Impact of timestamp accuracy on the error budget of timeaware bridge

> Amin Abdul Molex Canada

> > June 2019

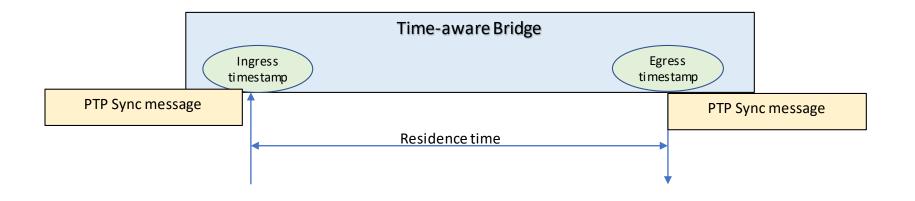
- It seems that "IEC/IEEE 60802 D1.0 TSN Profile for Industrial Automation" table 15 and 16 specifications are contradicting each other in term of maximum error contribution and timestamp accuracy
- It seems that table 15 is not taking into account the number of timestamps required to compute the residence time and link delay measurement
- The following slides will elaborate on potential error sources as well as the number of timestamps required to compute PTP residence time and link delay measurement.

PTP residence time computation

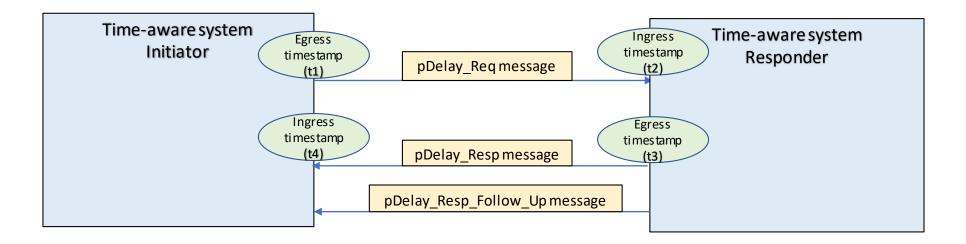
- The <residenceTime> corresponding to the time interval between the receipt of a Sync message on the ingress PTP Port and the transmission or retransmission of that Sync message on an egress PTP Port ... [IEEE1588-2018 D1.4V4_11 Clause 16.10.4.4]
- PTP residence time computation requires 2 timestamps
- Suggestion: Maximum residence time error should be "(2 x timestamp_accuracy_ns) 2_ns"

- Maximum residence time error (max_rt_err) should be "(2 x timestamp_accuracy_ns) 2_ns"
- Maximum link delay error (max_ld_err) should be "((4 x timestamp_accuracy_ns) 4_ns)/2"
- Should account for link asymmetry measurement error (link_asym_err)
- Should account for HW adjustment error (hw_adj_err)
- Error budget per time-aware bridge in ns should be
 - MAX { (max_rt_err + max_ld_err + link_asym_err + hw_adj_err), 25 }
- Computation of the number of hops in "IEC/IEEE 60802 D1.0 TSN Profile for Industrial Automation" table 14 should reflects the error budget per time-aware bridge
